Development Review Hearing

**Item 6 : PLN25-00295
2892 Mesquite Drive**

November 19, 2025

Rendering

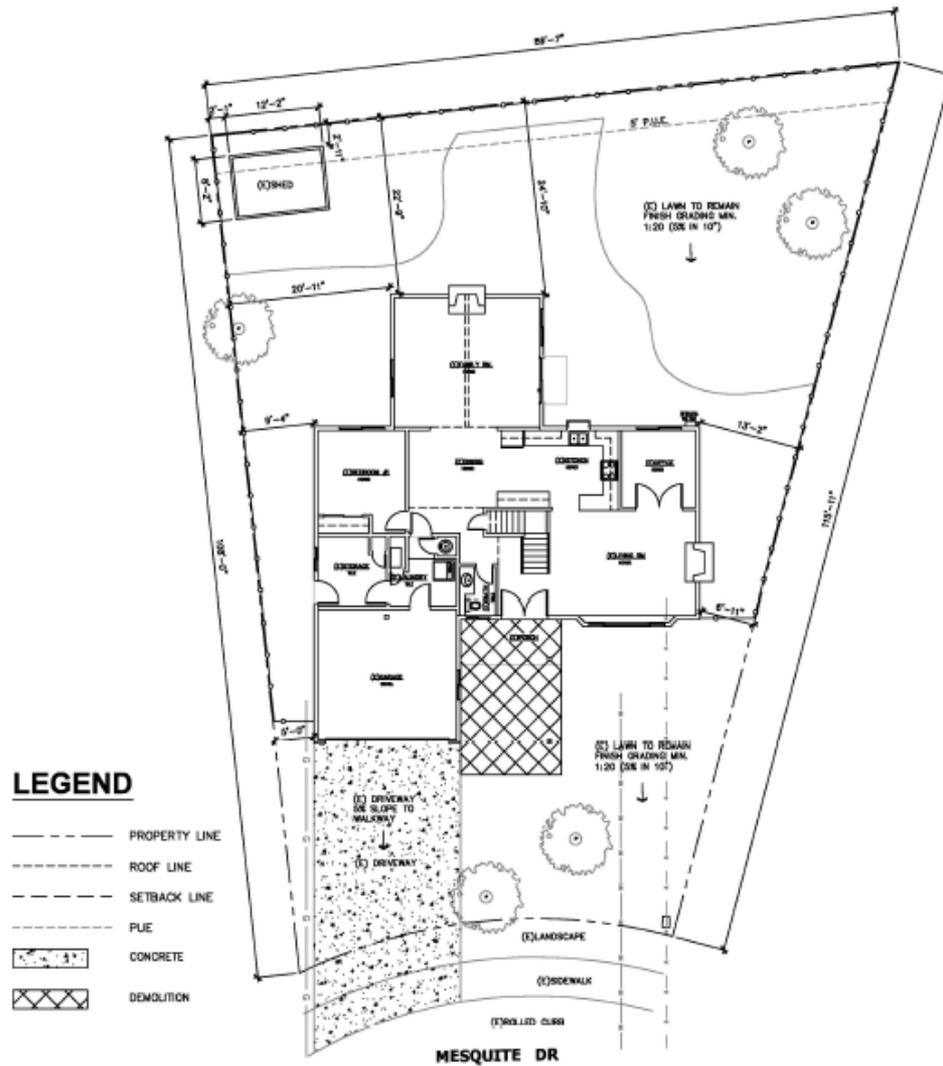
The entry feature's height as proposed is higher than the rest of the first-floor roof line.

- The height of the entry feature be reduced to match the rest of the first floor or be below it.
